Siphon Break – Sport Jet

NOTICE

Revised September 1998. Destroy original May 1998 Bulletin. Changes are underlined.

Sport Jet 175XR² – Serial number **0E288000** thru **0E341671**

- a** - Clamp for Siphon Break
- b** - Siphon Break
- c** - Screen End which Lays in Bilge

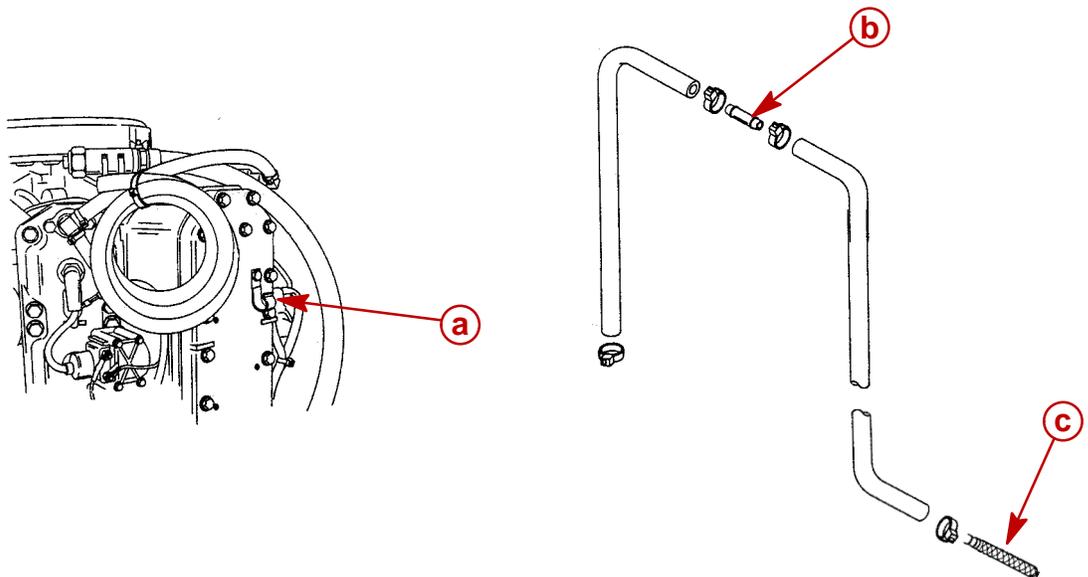
It has recently come to our attention that the hole in the siphon break may be “flashed over” (not open). This condition may allow water to siphon back into the boat after the engine is turned off. Water siphoning back into the boat can only occur when water is being drawn out through the siphon system at the time the engine is turned off.

Siphon break and hose assembly are secured to the exhaust manifold with an open end clamp. Remove assembly from the clamp. Cut the cable ties securing both hoses to the siphon break. Replace siphon break with new part and secure siphon break to hoses using new cable ties. Reinstall siphon break assembly to clamp on exhaust manifold.

Order : Qty. 1 of 826702 Siphon Break
 Qty. 2 of 816311 Cable Tie
